From: Brisbane Baylands Community Advisory Group

Re: Brisbane Baylands Draft Environmental Impact Report

Subject: 4.G-23, Brisbane Landfill, Paragraph 3: *“The depth of the waste layer is estimated to range from 20 to 30 feet.” “...the area was subsequently buried with a 20- to 30- foot cover of soil to prevent future direct human contact with refuse.”*

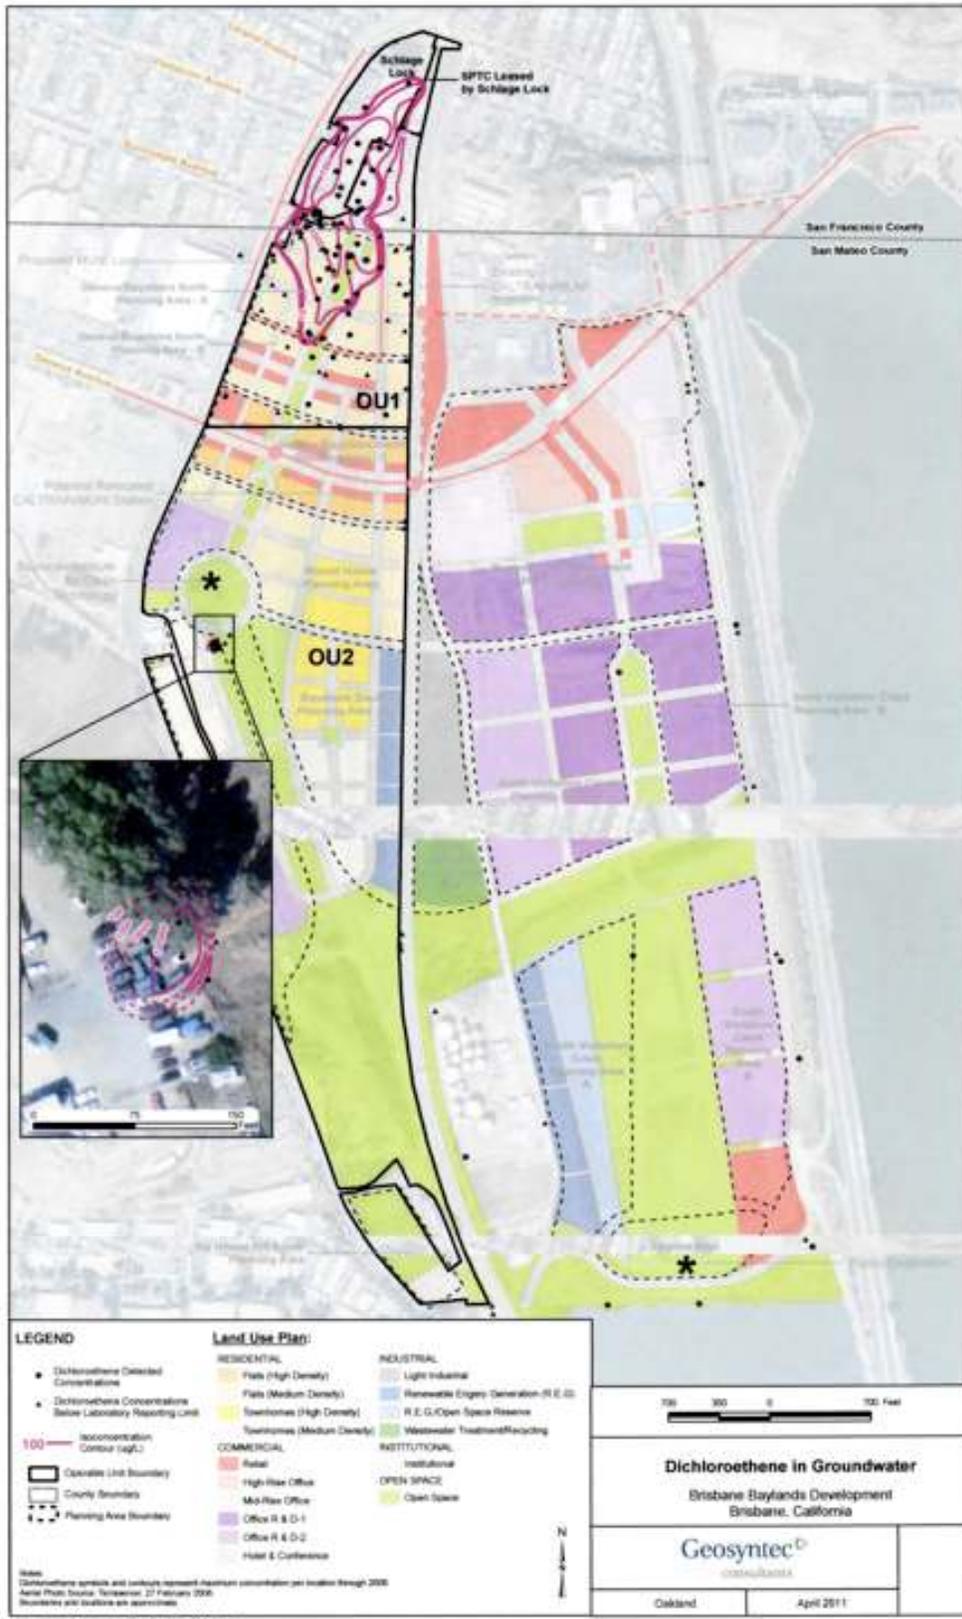
Comment: This is incorrect. Near the lagoon, the waste layer is thinner and hardly has 20 feet of soil cover. Again, accurate information is needed, not Geosyntec's version of reality.
